PD Modification Application: PRS 23-0030

BOCC Land Use Meeting Date: March 7, 2023

Applicant: TC Venture 2, LLC

APPLICATION NUMBER: PRS 23-0030

Figure 7.1 Project Roadways (provided by applicant)

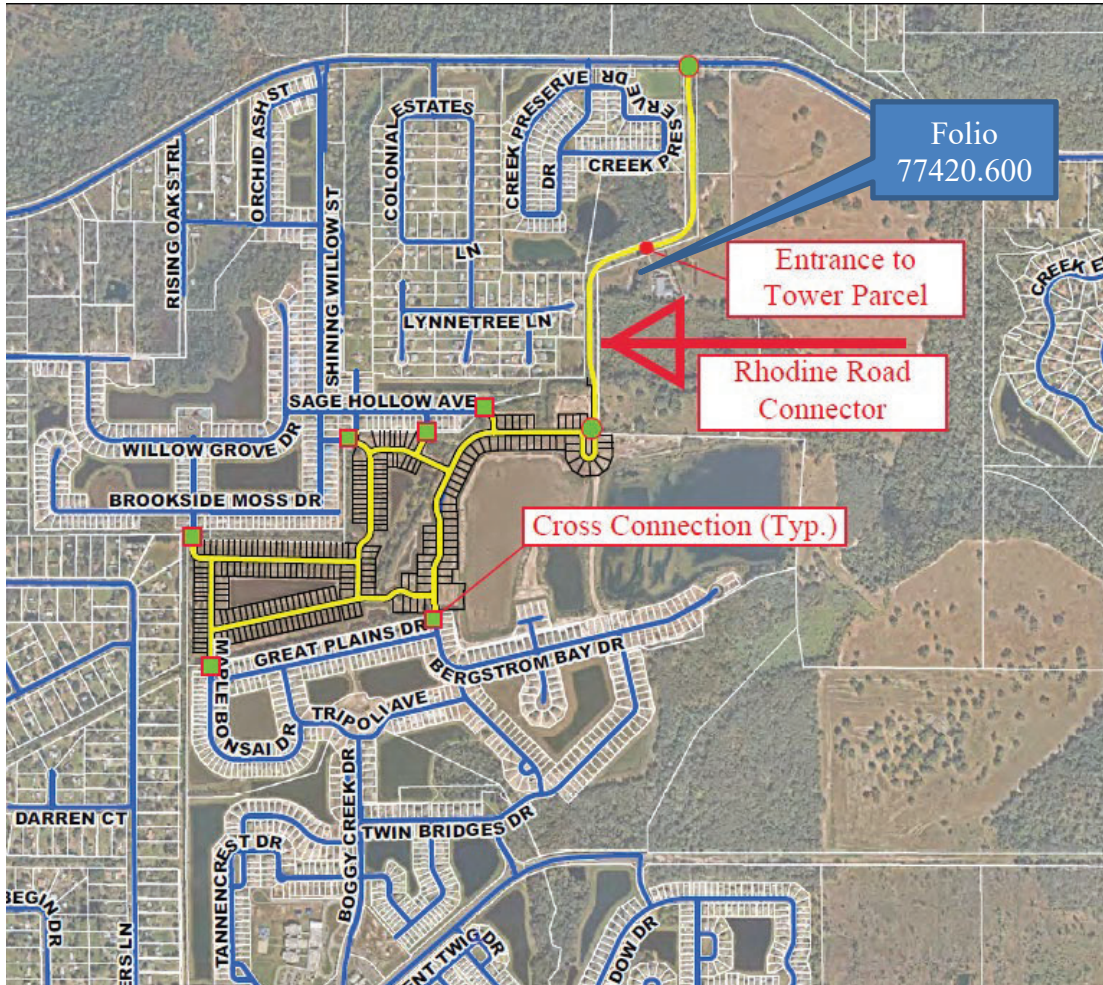
Existing Approval(s):	Proposed Modification(s):
Construct Colonnade Vista Drive (aka Rhodine Road Connector) to serve both the subject site and folio 77420.6000	Construct Colonnade Vista Drive (aka Rhodine Road Connector) in two segments: <ul style="list-style-type: none"> • Bergstrom Bay Drive to the entrance of folio 77420.6000 (south segment) • the entrance of folio 77420.6000 to Rhodine Road (north segment)
Construct Colonnade Vista Drive (aka Rhodine Road Connector) to serve both the subject site and folio 77420.6000	Prohibit the filing of building permit applications for more than 75% of the residential units until substantial completion of the South Segment and a posted performance bond guaranteeing the completion of the North Segment is accepted by the County. Prohibit the issuance of building permits for more than 75% of the residential units until the substantial completion of the North Segment.

12. The developer shall construct an internal project roadway beginning at Rhodine Road and continuing for a distance of approximately 3,650 ft (i.e. to the south most point of the area of modification shown on the PD site plan for PRS 23-0030, hereafter referred to as the "Rhodine Road Connector"). The Rhodine Road Connector shall be constructed in two segments: (1) first, the southernmost +/- 1,850 ft (i.e., between the southmost point of the Rhodine Road Connector and the existing entrance into Folio 77420.6000 (the "South Segment"); and, (2) second, from the existing entrance into Folio 77420.6000 to Rhodine Road (the "North Segment").

The image below depicts the entire Rhodine Road Connector, which is the area of requested PRS amendment for the subject PRS.

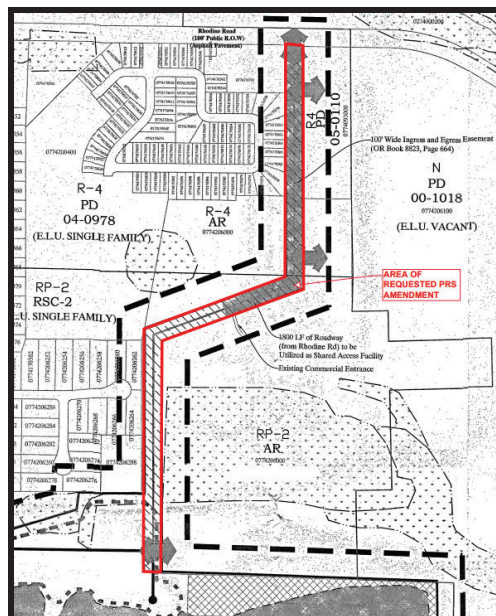
PD 18-0304 includes a requirement to construct an internal project roadway beginning at Rhodine Road and continuing for a distance of approximately 3,650 ft (i.e. to the south most point of the area of modification shown below and on the PD site plan for PRS 23-0030 referred to as the “Rhodine Road Connector”). The applicant proposes in the subject PRS to split the required internal project roadway into two segments. The first segment proposed is the southernmost +/- 1,850 ft (i.e. between the southmost point of the Rhodine Road Connector and the existing entrance into Folio 77420.6000 (the “South Segment”). The second segment starts from the existing entrance into Folio 77420.6000 to Rhodine Road (the “North Segment”).

The applicant also proposes specific conditions that connect the construction of the Rhodine Road Connector to the issuance of building permits for the last 25% of the approved residential units. The revised conditions allow for 75% of building permits for the previously approved residential units to be issued without the Rhodine Road Connector. Building permits for the remaining 25% of the residential units may be applied for (but not issued by the County) when the first segment of the Rhodine Road Connector is substantially completed, and a performance bond is posted (and accepted by the County) for the second segment of the Rhodine Road Connector. The building permits for the remaining 25% of the residential units may be issued when the second segment of the Rhodine Roadway Connector is substantially completed. The applicant is required to modify the subdividers agreement to include the proposed revised condition language in the subject PRS. The applicant has worked with staff on the proposed revised conditions and the two-segment approach for the Rhodine Road Connector. As a result, transportation staff does not object to PRS 23-0030 subject to the included revised condition and new conditions of approval.

12. The developer shall construct an internal project roadway beginning at Rhodine Road and continuing for a distance of approximately 3,650 ft (i.e. to the south most point of the area of modification shown on the PD site plan for PRS 23-0030, hereafter referred to as the “Rhodine Road Connector”). The Rhodine Road Connector shall be constructed in two segments: (1) first, the southernmost +/- 1,850 ft (i.e., between the southmost point of the Rhodine Road Connector and the existing entrance into Folio 77420.6000 (the “South Segment”); and, (2) second, from the existing entrance into Folio 77420.6000 to Rhodine Road (the “North Segment”).

The image below depicts the entire Rhodine Road Connector, which is the area of requested PRS amendment for the subject PRS.

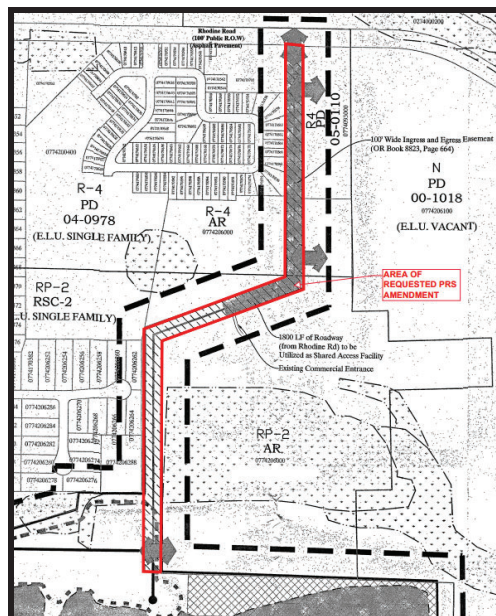
PD 18-0304 includes a requirement to construct an internal project roadway beginning at Rhodine Road and continuing for a distance of approximately 3,650 ft (i.e. to the south most point of the area of modification shown below and on the PD site plan for PRS 23-0030 referred to as the “Rhodine Road Connector”). The applicant proposes in the subject PRS to split the required internal project roadway into two segments. The first segment proposed is the southernmost +/- 1,850 ft (i.e. between the southmost point of the Rhodine Road Connector and the existing entrance into Folio 77420.6000 (the “South Segment”). The second segment starts from the existing entrance into Folio 77420.6000 to Rhodine Road (the “North Segment”).

The applicant also proposes specific conditions that connect the construction of the Rhodine Road Connector to the issuance of building permits for the last 25% of the approved residential units. The revised conditions allow for 75% of building permits for the previously approved residential units to be issued without the Rhodine Road Connector. Building permits for the remaining 25% of the residential units may be applied for (but not issued by the County) when the first segment of the Rhodine Road Connector is substantially completed, and a performance bond is posted (and accepted by the County) for the second segment of the Rhodine Road Connector. The building permits for the remaining 25% of the residential units may be issued when the second segment of the Rhodine Roadway Connector is substantially completed. The applicant is required to modify the subdividers agreement to include the proposed revised condition language in the subject PRS. The applicant has worked with staff on the proposed revised conditions and the two-segment approach for the Rhodine Road Connector. As a result, transportation staff does not object to PRS 23-0030 subject to the included revised condition and new conditions of approval.

12. The developer shall construct an internal project roadway beginning at Rhodine Road and continuing for a distance of approximately 3,650 ft (i.e. to the south most point of the area of modification shown on the PD site plan for PRS 23-0030, hereafter referred to as the “Rhodine Road Connector”). The Rhodine Road Connector shall be constructed in two segments: (1) first, the southernmost +/- 1,850 ft (i.e., between the southmost point of the Rhodine Road Connector and the existing entrance into Folio 77420.6000 (the “South Segment”); and, (2) second, from the existing entrance into Folio 77420.6000 to Rhodine Road (the “North Segment”).
